AMENDMENT OF SOLICITATION/MODIFICATION OF CONTRACT

2. AMENDMENT/MODIFICATION NO. AMENDMENT NO. 0006	3. EFFECTIVE DATE 05/13/14	4. REQUISITION/PURCHASE REQ. NO.	5. PROJECT NO. (If applicable) 13-0073
---	-------------------------------	----------------------------------	---

14. DESCRIPTION OF AMENDMENT/MODIFICATION (Organized by UCF section headings, including solicitation/contract subject matter where feasible.)
13-0073 Interior/Exterior Repairs, Bldg 324

1 TEMPORARY TRAILERS - ELECTRICAL
 E-105E-105 CONSTRUCTION Scale: 1/4" = 1'-0"

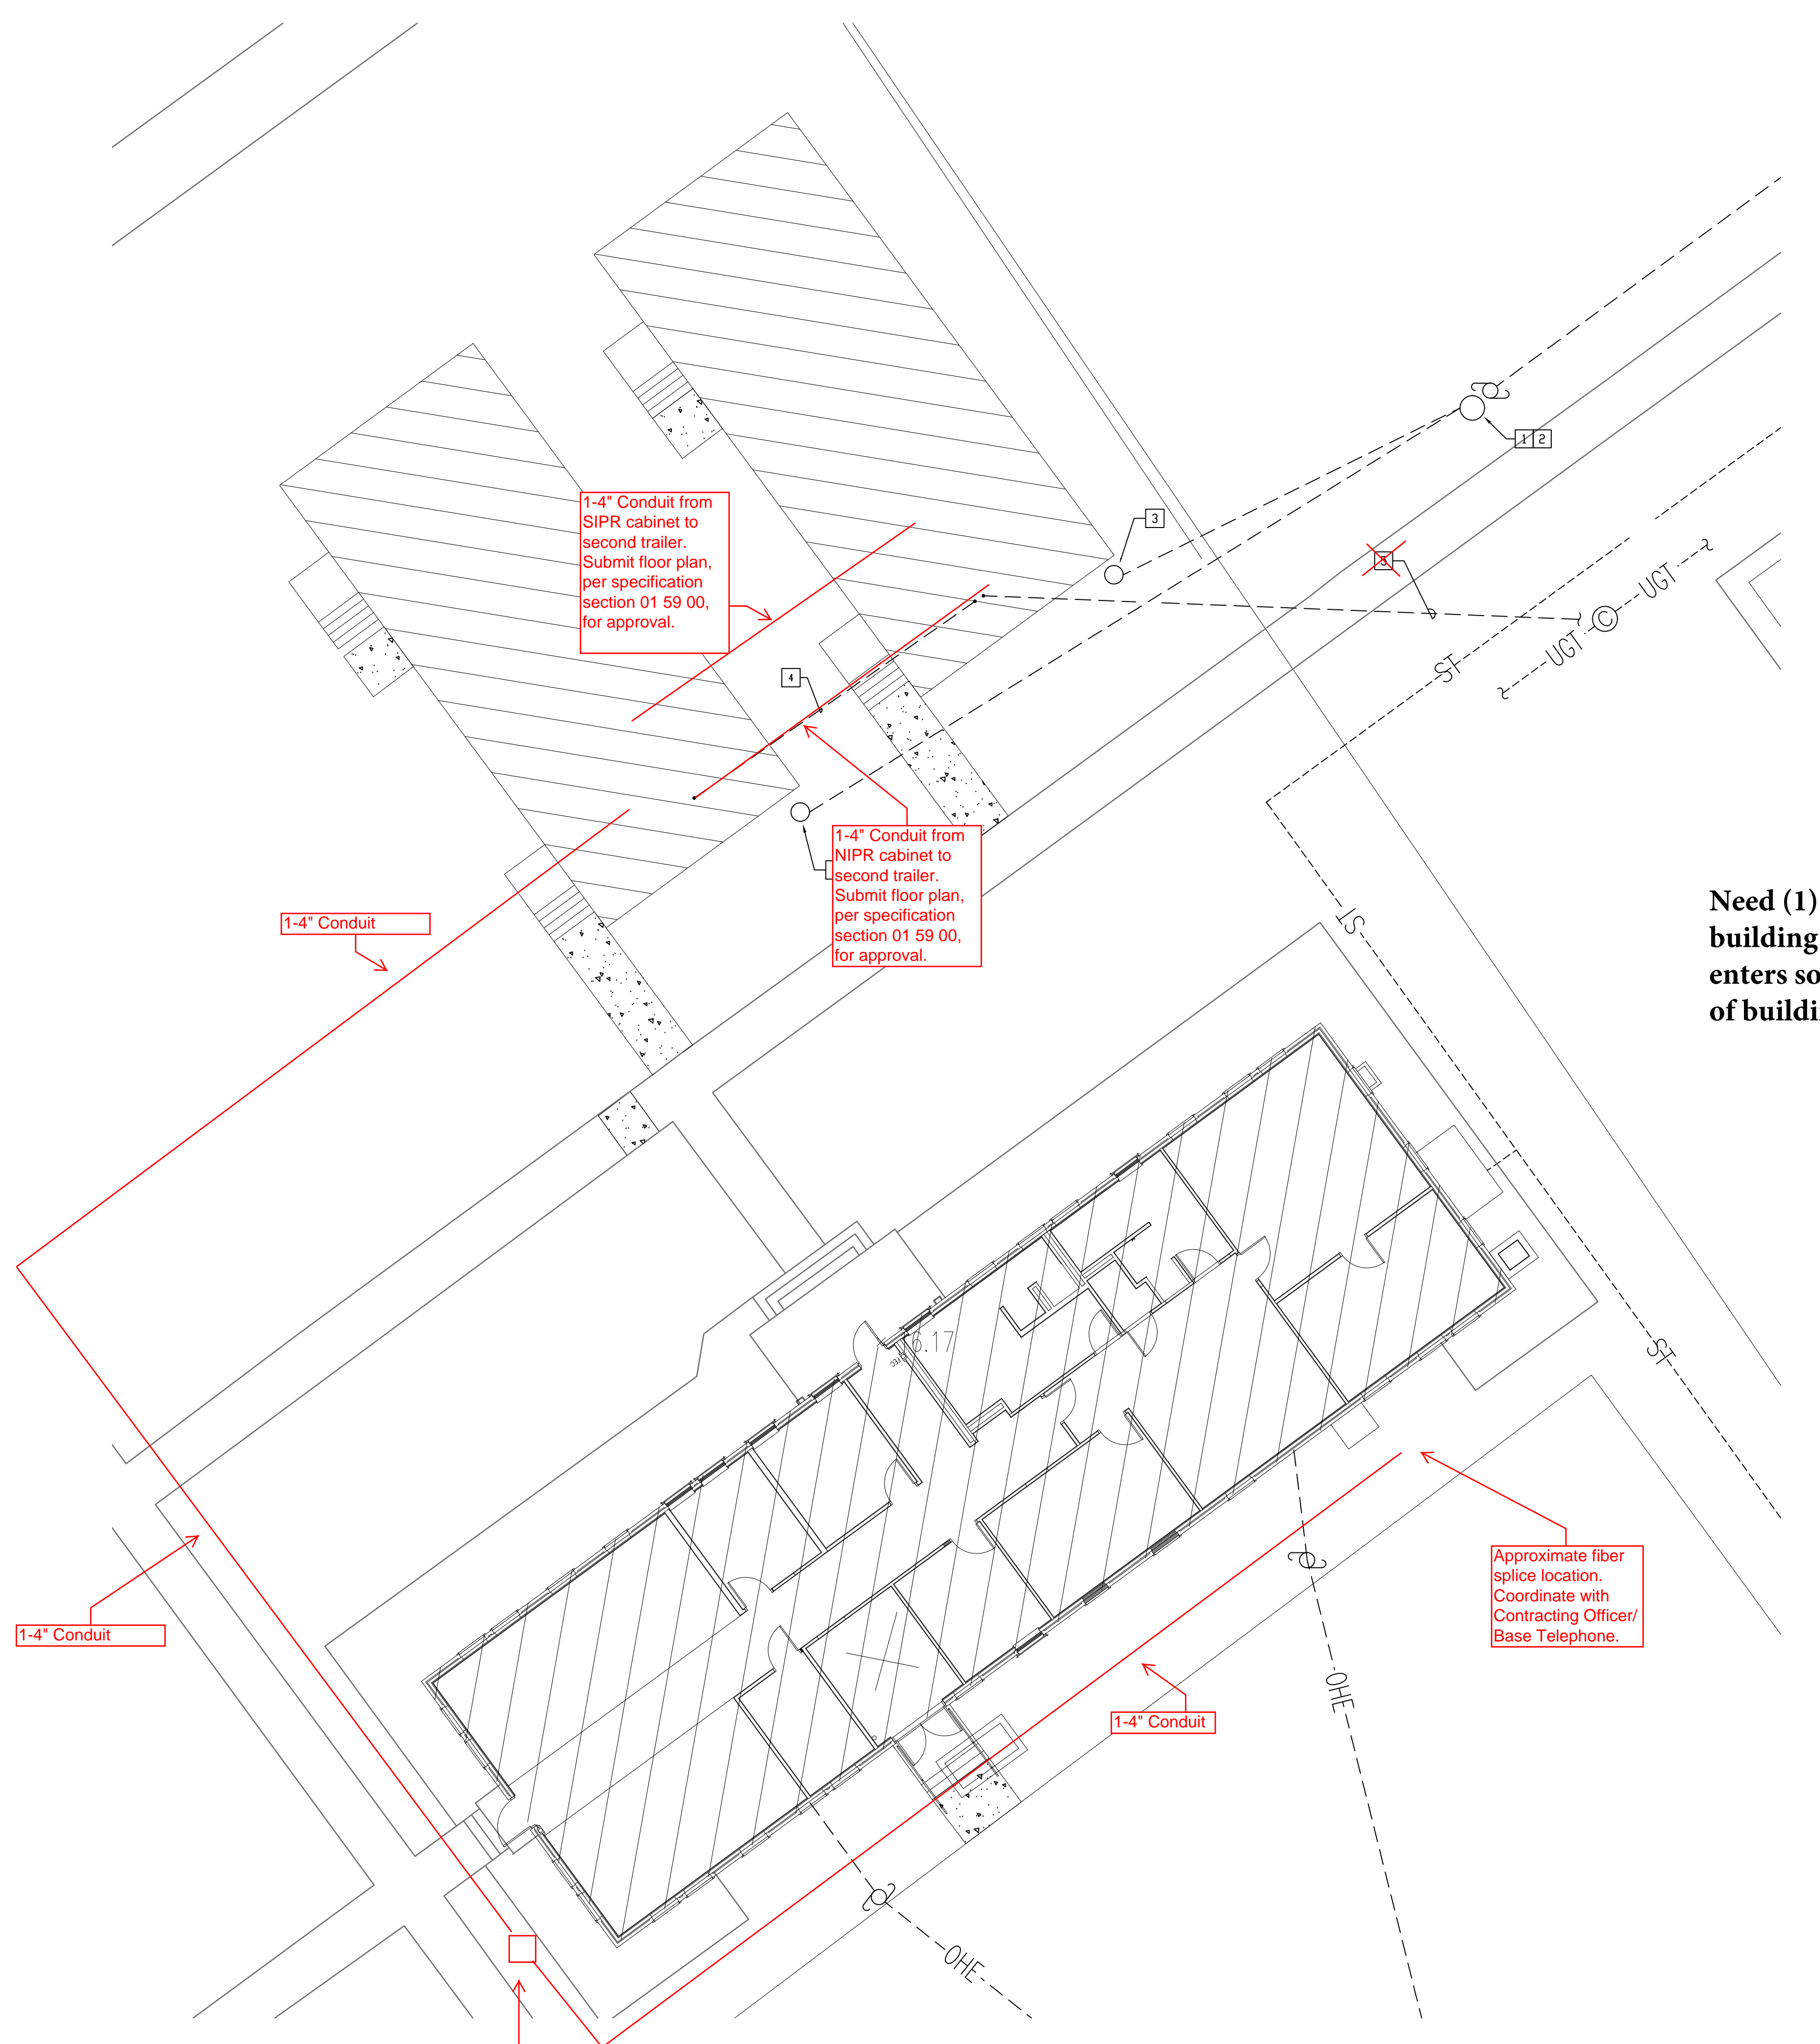
Need (1) 4" conduit to building where cable enters so we can pull out of building and splice

- PLAN NOTES:**
- 1 CONNECT TO EXISTING OVERHEAD ELECTRICAL SERVICE IN THIS AREA.
 - 2 NEW TEMPORARY ELECTRICAL SERVICE POLE WITH 2-75 KVA POLE-MOUNTED TRANSFORMERS (12.5KV PRIMARY, 208/1 SECONDARY VOLTAGE). SEE RISER DIAGRAM.
 - 3 NEW TEMPORARY ELECTRICAL SERVICE POLE WITH DISCONNECT FOR TRAILER. CONNECT FROM DISCONNECT TO ELECTRICAL PANEL IN TRAILER. VERIFY EXACT TERMINATION POINT WITH EQUIPMENT SUPPLIER. SEE RISER DIAGRAM.
 - 4 STUB 1-4" CONDUIT FROM MAIN COMMUNICATIONS AREA IN TRAILER TO SECONDARY TRAILER. COORDINATE WITH BASE NEC FOR COPPER AND FIBER REQUIREMENTS. VERIFY EXACT TERMINATION POINT WITH CONTRACTING OFFICER.
 - 5 ~~STUB 1-4" CONDUIT WITH 3-CELL MAXCELL INNERDUCT FROM MAINTENANCE HOLE TO MAIN COMMUNICATIONS CABINET. COORDINATE WITH BASE NEC FOR COPPER AND FIBER REQUIREMENTS.~~
